## **APPENDIX 2**

PLANNING SUBMISSION PROPOSED COMMERCIAL DEVELOPMENT AT LOT 52

## ITEM 2 PROPOSED FIVE STOREY COMMERCIAL DEVELOPMENT AT LOT 525 (35) DAVIDSON TERRACE

DAVIDSON TERRACE ELEVATION SCALE 1: 100

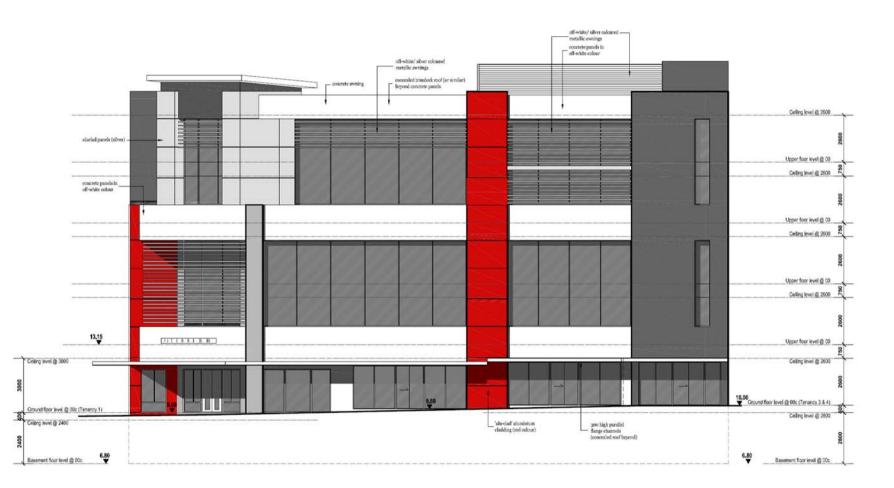
- Raised concerns with the design of the building especially as it's located within the City Centre. Height of the building is good, however, it needs the quality to go with it.
- Concerned in relation to the environment and the use of mechanical air conditioning.
- The need to reconsider the corner of the building as it's the most visual and a prominent element is needed.
- Advised that more information should be provided on the materials to be used.
- Suggested that a schedule of completion be provided by the applicant.
- Queried the location of the rain water tanks.
- Queried the sun shading and how the windows will be treated on the western elevation.
- Concerned about the lack of details not being available at the approval stage.

- Advised that the materials to be used are not clearly stated by the applicant.
- Concerned that the corner element does not reflect that this site is a landmark.
- Queried the location of solar energy panels and rain tanks and that it's not reflected on the plans. The Panel advised that this should be shown on the plans and that this comment should be forwarded to Architect.
- Advised that more detail should be shown on the plans and that not enough information has been provided in relation to awnings and sun shading.
- Queried the extended glazing on the western side of the development and that due to the amount of glazing, the site will rely heavily on mechanical air conditioning.
- Advised that if no sun shading is provided, the air conditioning units will be large in size and for a prominent landmark building, will not provide a good look for the City Centre.

SOUTH ELEVATION

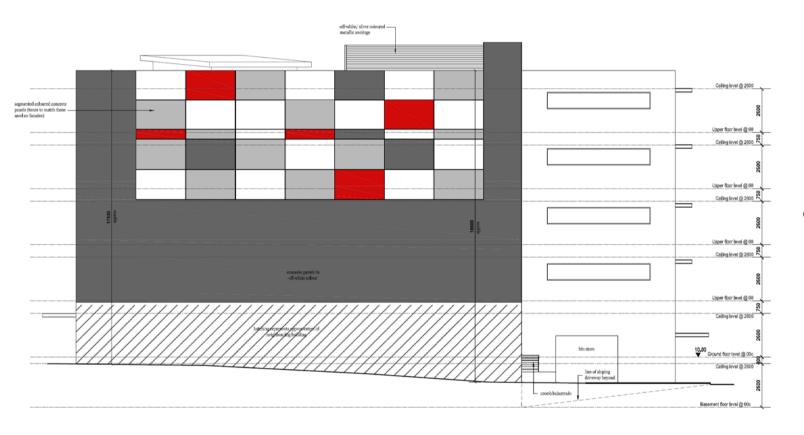
ANTHONY& ASSOCIATES NOTE: Decorative mouldings/ recesses on South facade to be designed during working drawings stage and to meet council satisfaction.
